# SAFETY RECALL NOTICE

## QUICK-RELEASE MECHANISMS

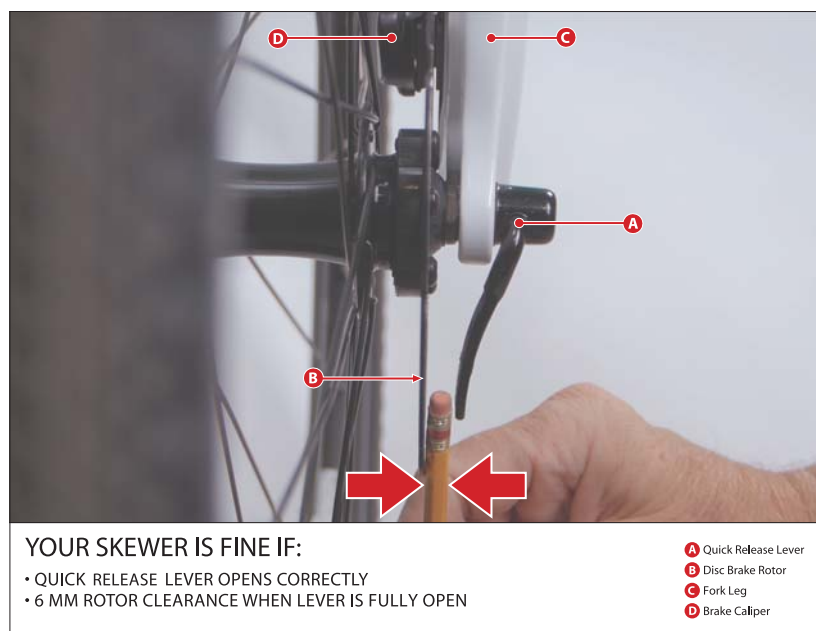
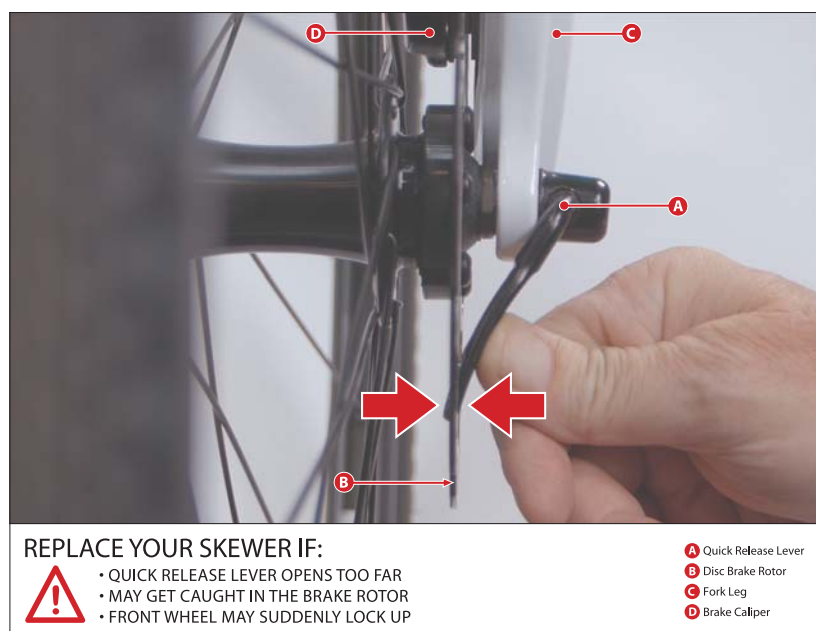
Front-wheel quick-release cam levers that are improperly adjusted or left open during riding and do not meet the #2 Pencil Test below may potentially interfere with the front disc brake rotor, which could result in the rider losing control and sustaining serious personal injuries.

This is a Safety Recall Notice regarding a group of bicycle brands listed below. Only bicycles equipped with front-wheel quick-releases and disc brakes are potentially affected. If the distance between the leading edge of the cam lever in its most open position and the disc rotor is less than 6 millimeters, which is the equivalent of the width of a standard #2 pencil (the “#2 Pencil Test”), your quick-release mechanism needs to be replaced. Please visit [www.quickreleaserecall.com](http://www.quickreleaserecall.com) for a video demonstration of the #2 Pencil Test.

Stop riding the affected bicycle immediately and bring it to an authorized retailer of your bicycle’s brand, which will replace the affected quick-release free of charge. For any inquiries, please go to [www.quickreleaserecall.com](http://www.quickreleaserecall.com), click on the brand of your bicycle, and proceed from there.
